Fish and Game Question	Response	Who has responded
1. Contaminant pathway to downstream water bodies		
<p>My understanding from the technical documents is that mine contaminants will reach the Lindis, Clutha, and Lake Dunstan via two pathways:</p> <p>a) treated surface water discharging to Shepherds Creek, infiltrating to groundwater, and resurfacing downstream; and</p> <p>b) direct groundwater seepage from the ELFs and TSF, which resurfaces downstream.</p> <p>I have written many of the following questions on this understanding. For the sake of clarity, can you confirm that this is correct?</p>	<p>Mine impacted water (MIW) will be treated where required to meet water quality compliance limits at SC01 and RS03. Recommended water quality compliance limits have been set by Ryder¹ (2025) to manage human impacts and ensure ecosystems, stock water, and drinking water remain safe. Any solute loads further downstream (e.g., in the Lindis River, Clutha River, Lake Dunstan) would simply be lesser again due to catchment dilution.</p> <p>As discussed further in the response to RFI#2, high levels of Mine Waste Storage Facility (MWSF, i.e., engineered landforms (ELFs) and the tailings storage fac

Figure A1: Groundwater - Vertical Hydraulic Gradients
Bendigo-Ophir Gold Project

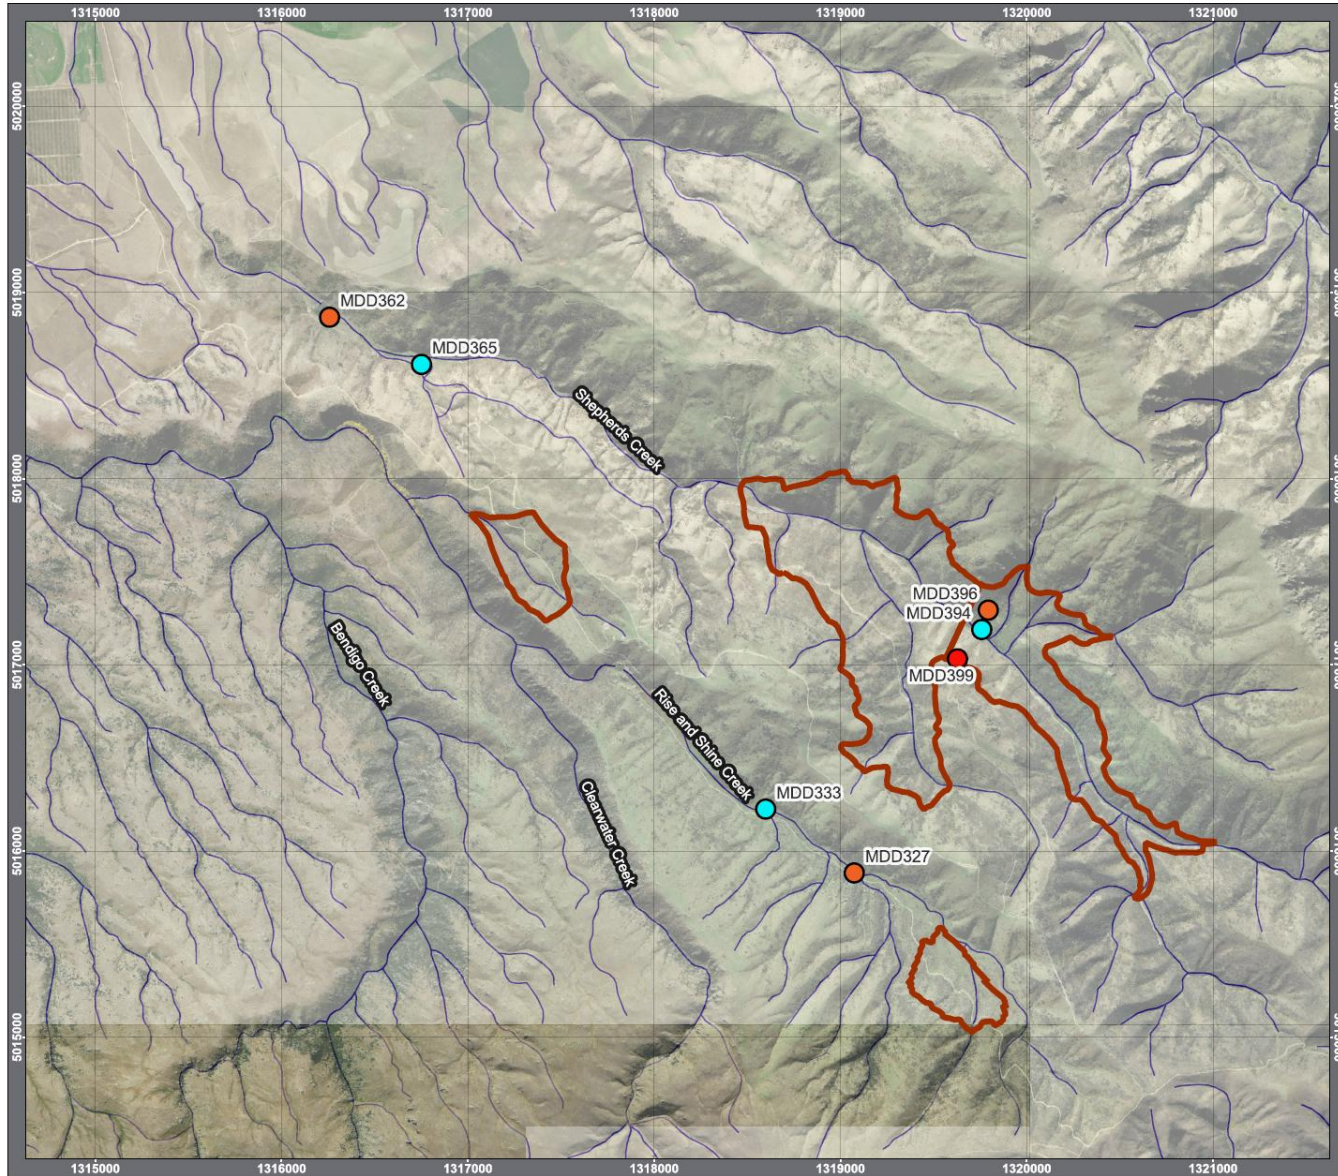
2. Scale of seepage to groundwater and contradictory statements		
<p>What is the expected volume and contaminant loading of seepage to groundwater from the ELF and TSF?</p> <p>The application contains contradictory statements:</p> <p>a) Engineering reports (B.21, Section 14.6) state drains will "capture most of the tailings seepage" with "any seepage into the underlying groundwater will be minor"</p>	<p>To clarify, the formation of the TSF within Shepherds Valley enables effective collection and management of tailings seepage water during operations and in closure. Shepherds TSF will incorporate a series of underdrains installed along the valley floor and along the upstream side of the embankment forming the TSF to intercept seepage. This underdrainage system will collect seepage generated from the tailings. Any residual seepage that migrates past the TSF embankment will be intercepted downstream beneath the ELF through toe underdrainage well before it reaches potential downstream receptors, i.e. the Ardgour Terrace and Lindis Aquifer. The quantity of seepage from the TSF is expected to reduce over time. This is because as the tailings consolidate their permeability reduces and in closure tailings discharge will cease.</p> <p>The permeable gravels of the Ardgour Terrace and Lindis Aquifer are located more than 4 km downstream of the TSF. Any potential long, slow seepage pathways that may occur deep within the tight, low</p>	<p>EGL responses are provided by:</p> <ul style="list-style-type: none"> Eric Torvelainen Director Engineering Geology Limited BE (Hons), MEngNZ Eric has a BE (Hons) Civil from the University of Canterbury and has more than 15 years' experience in geotechnical and earthquake engineering, for

Fish and Game Question	Response	Who has responded
	<p>allowed on the TSF to manage all operational situations plus a Probable Maximum Flood, plus 1 m freeboard for wave action.</p> <p>As clarified above, seepage will be collected and treated. Only a minor amount of seepage may bypass the collection system. Performance monitoring will confirm that any bypass is minor and will meet the water quality and aquatic standards. If the water quality and aquatic standards were not being met there are contingency measures, such as grout curtains and pump wells, which will be effective in the constrained valley that means the residual risk to the Ardgour and Lindis Aquifer is low i.e. the site can be effectively managed and controlled even if seepage bypassed the proposed collection system as seepage primarily reports in the valley floor.</p>	
<p>What volume of seepage will bypass capture systems and enter groundwater?</p>	<p>MWSFs that include the TSF and ELFs are planned to be situated within the deeply incised valleys at the BOGP. It is noted this is in contrast to Macraes Mine, an often-used nearby analogue, where many MWSFs are situated on a flatter plateau topographic setting. At BOGP, the hydrogeological setting is favourable for achieving high levels (e.g., >80%) of seepage collection. The following site conditions indicate this:</p> <ul style="list-style-type: none"> • Groundwater data presented in KSL (2025b)² and EGL (2025b)³ show the high elevation ridges have higher hydraulic head than the valley bottoms (e.g., Shepherds Creek). • Vertical gradients from VWP1 data in EGL (2025c)⁴ generally show downwards gradients on valley sides and upwards gradients in valley bottoms. See Figure A1 in Attachment A of this letter report 	<p>MWM</p>

Fish and Game Question	Response	Who has responded
	<p>for presentation of these data. Both these conditions support the interpretation of the valley bottoms, where MWSFs will be placed, to be zones of groundwater discharge.</p> <ul style="list-style-type: none"> • Alluvium within the valley bottoms, the likely main seepage groundwater transport pathway is typically shallow (less than 5 m deep in the vicinity of MWSFs). See Figure A2 in Attachment A of this letter report for presentation of this data sourced from EGL (2025c). <p>In addition, seepage control elements are planned to ensure enhanced seepage collection, including:</p> <ul style="list-style-type: none"> • At the TSF: underdrains, a chimney drain, and a cutoff drain. These drains will convey collected seepage to a lined sump. See EGL (2025b)⁵. • At the MWSF: underdrains and a toe sump. See EGL (2025h)⁶. <p>In summary, given the hydrogeological conditions at the BOGP and the planned seepage collection elements included in the MWSF designs, it is reasonable to expect high levels of seepage collection (or low rates of bypass). Contaminant transport modelling will be completed to support detailed design of these seepage collection systems to achieve appropriate levels of seepage collection.</p> <p>Once in operation, performance monitoring is proposed (see the Water Management Plan⁷) to confirm seepage collection systems are functioning as planned. If it turns out they are not, then the favourable hydrogeological conditions and long flow paths mean</p>
